RECALL REPAIR INSTRUCTIONS

KZ-2021-005

INSPECTION OF THE WINNTEC MODEL #6020 REGULATOR

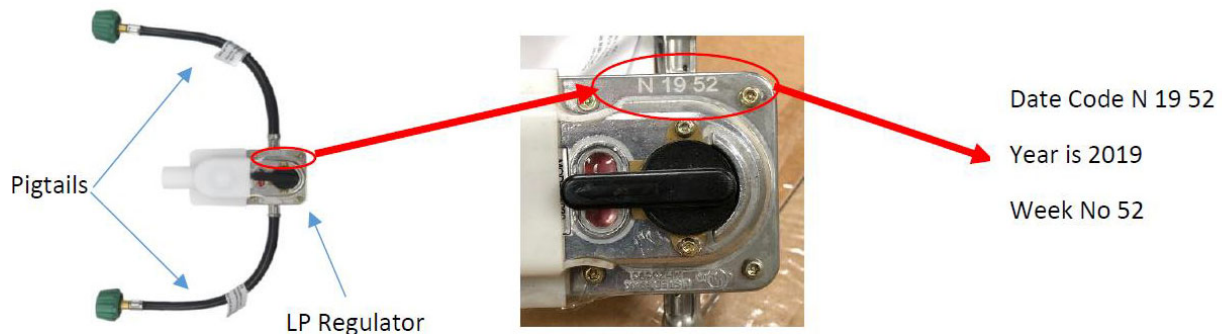
1. Only the Winntec Model #6020 - Dual Stage Double Cylinder - Automatic Changeover Regulator with Pigtails is affected. Replace the regulator and pigtails if the manufacturing date code stamped into the regulator is 2018, 2019 or 2020. Example shown below.
